1. TITLE (Class, Function, Type, etc.) <b>Component Package, LCC-18, Ceramic Crack</b>		2. DOCUMENT NUMBER <b>FV5-A-07-01B</b>
		3. DATE (DD-MMM-YY) <b>01 August 2007</b>

## LCC-18 Ceramic Micro-crack Technical Review

### Supplemental Data for [GIDEP FV5-A-07-01](#)

Picture showing Green Dot and location

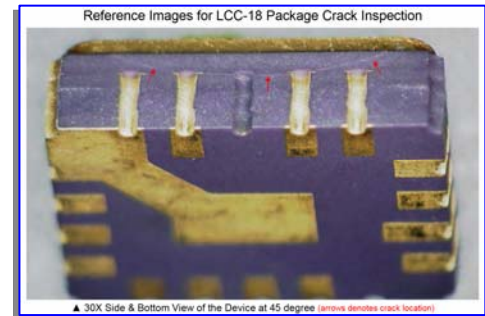
5. Beginning 6/20/2007, material returned to IR for micro-crack verification will be marked to indicate acceptance. IR will add a Green Dot marking to those returned devices that have passed 100% inspection for sidewall micro-crack. LCC-18 product returned to the field with the Green Dot will provide positive identification of the inspection for micro-crack and acceptability thereof. Packages inspected that are found to exhibit a micro-crack will be segregated for scrap disposition. See picture below for Green Dot reference.
